75W MODIFICATION TO APPLICATION TO  
BARANGAROO CONCEPT PLAN (MP06\_0162 MOD 8)

## MOD 8 DRAFT CONDITIONS | PART B – MODIFICATIONS TO CONCEPT PLAN **RESPONSE TO CONDITION B3**

16 FEBRUARY 2016

### 3.1 HICKSON PARK EAST / WEST VIEW CORRIDOR

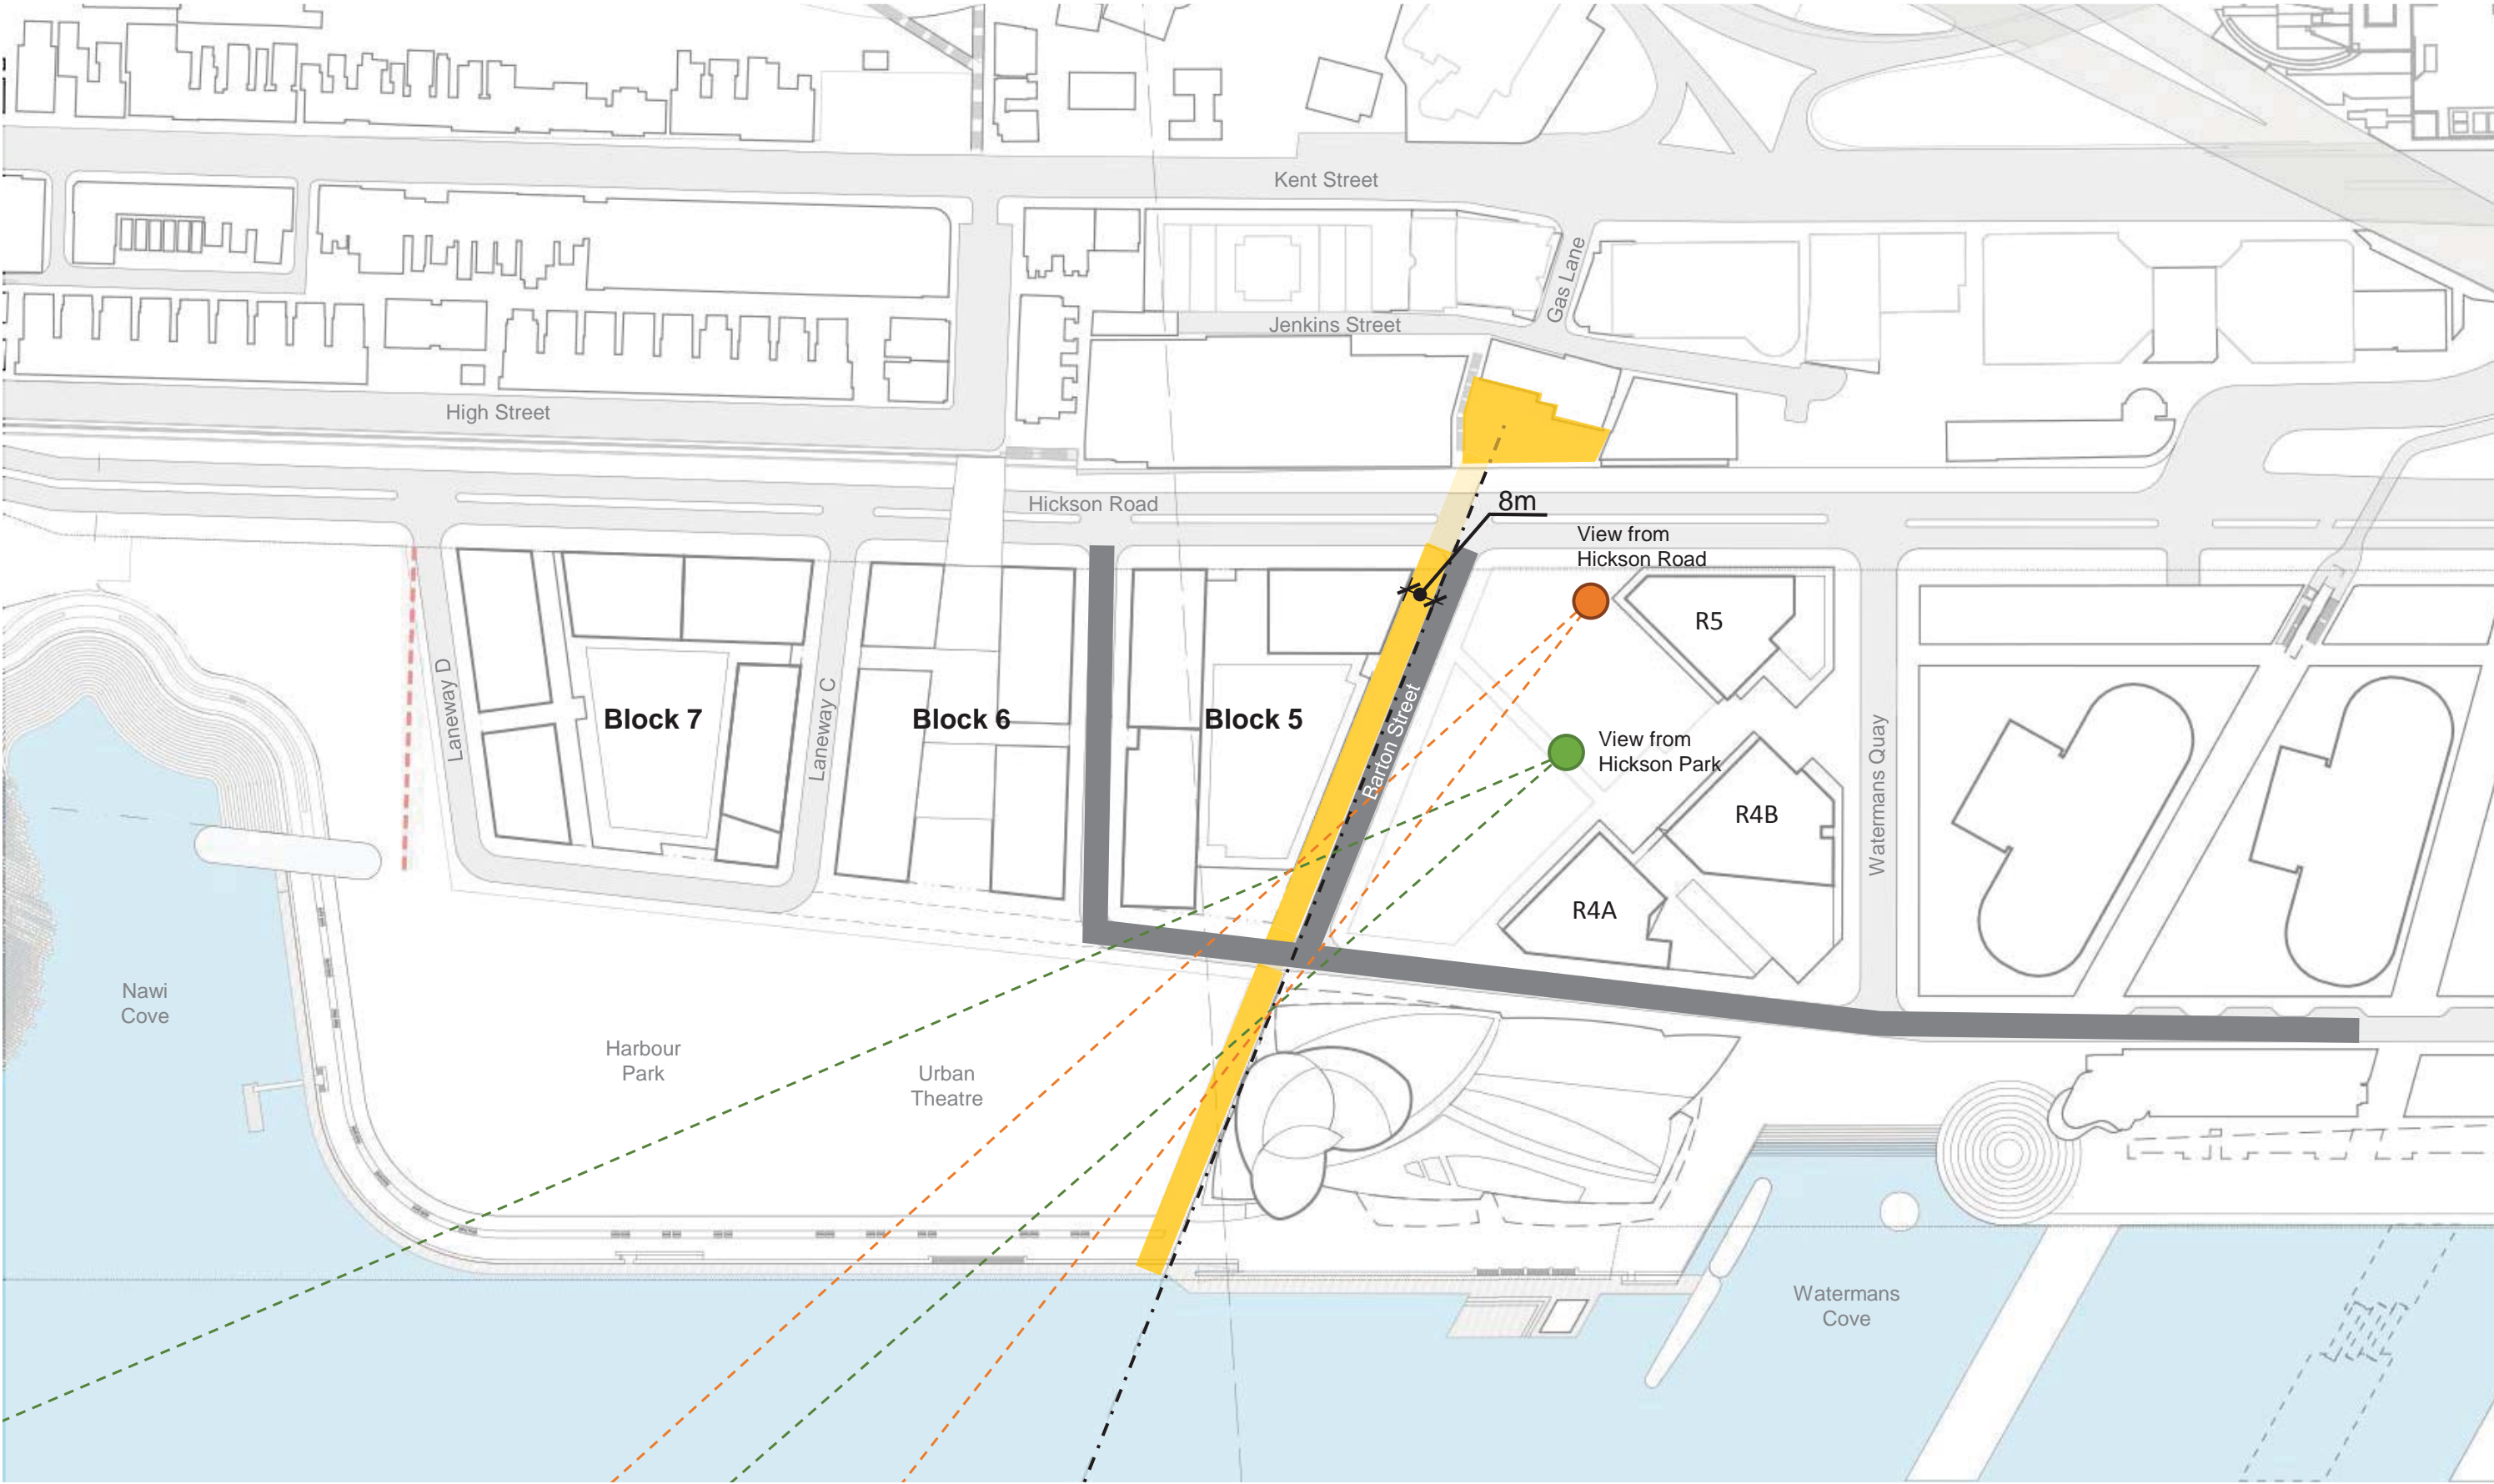
As a proposed revision, we have included the attached plan which the BDA has indicated it is prepared to support, along with view imagery that illustrates the axial shift of the key east/west view corridor that now extends beyond the northern end of the CSHR development on Block Y.

The revision results in an approximate minimum 28 metre view corridor between the northern edge of the development on Block Y and the south western corner of the development within Block 5 to the north.

As a result, the stated objectives of providing a key east/west view corridor and generous integrated landscape setting to the north of the Block Y building envelope has been achieved;

- The key east/west view corridor, with a minimum width of 20m, is shifted and re-aligned to provide full views past the northern edge of Block Y to the Central Parklands and the waters edge;
- The Concept Plan currently provides for a generous public domain space north of Block Y and, with the proposed revision, a stronger and more coherent connection is established between Hickson Park and the Central Parklands between Block Y & Block 5.

## 3.2 CSHR SOUTHERN ELEVATION & WATERMANS COVE

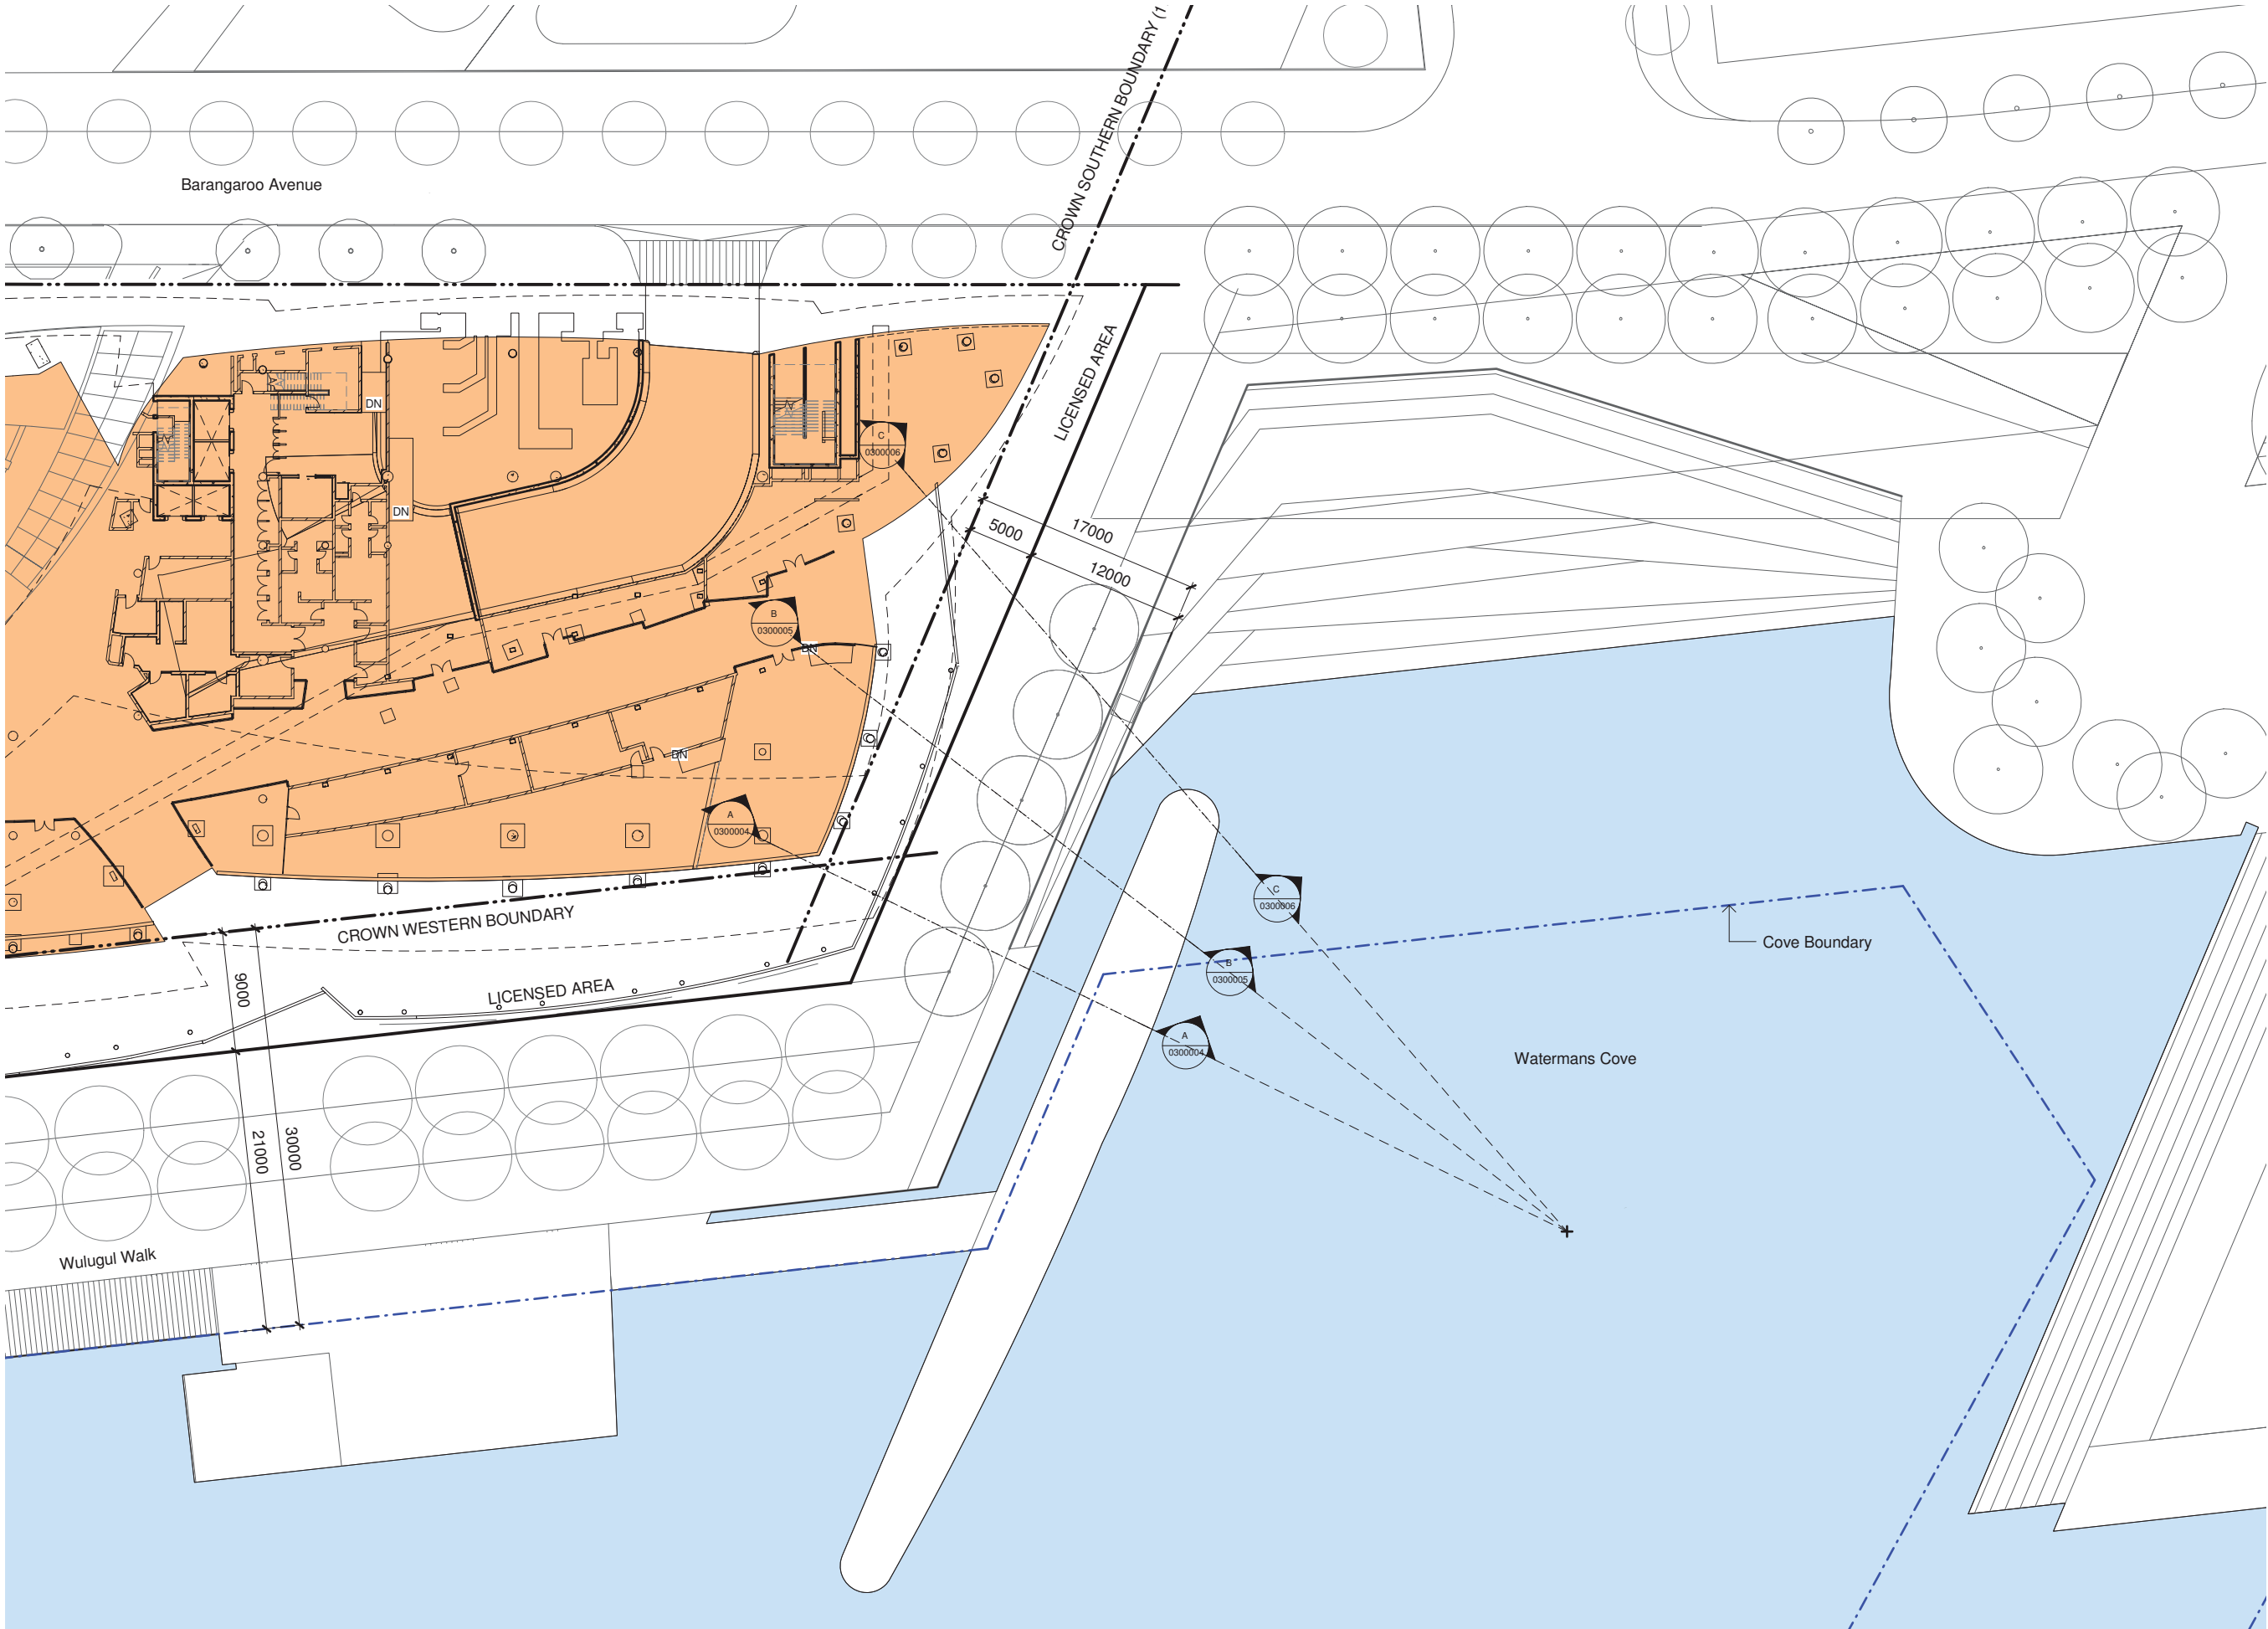
Currently, Mod 8 provides for a 17 metre setback between the podium on Block Y and the northern edge of the future Watermans Cove.

As a proposed design revision and solution to resolve the underpinning objectives, we have included the attached indicative design of Watermans Cove that now provides for an average 27.8 metre setback between the CSHR podium on Block Y and the northern edge of the future Watermans Cove. The proposed design of Watermans Cove will additionally increase the overall Public Promenade area to the south of the CSHR podium by 273m<sup>2</sup> whilst provide a minimum 18.5 metre wide clear unobstructed Public Promenade along the waters edge. The minimum 18.5 metre wide clear unobstructed Public Promenade along the edge of Watermans Cove is consistent with the minimum 18.5 metre wide clear unobstructed Public Promenade that has been established along the harbour edge to the south in front of R8 and R9.

In addition to increasing the setback of the podium from the waters edge, Crown Resorts is proposing to modify the design of the southern podium elevation per the attached plans in an effort to minimize any perception that the podium dominates and overwhelms Watermans Cove.
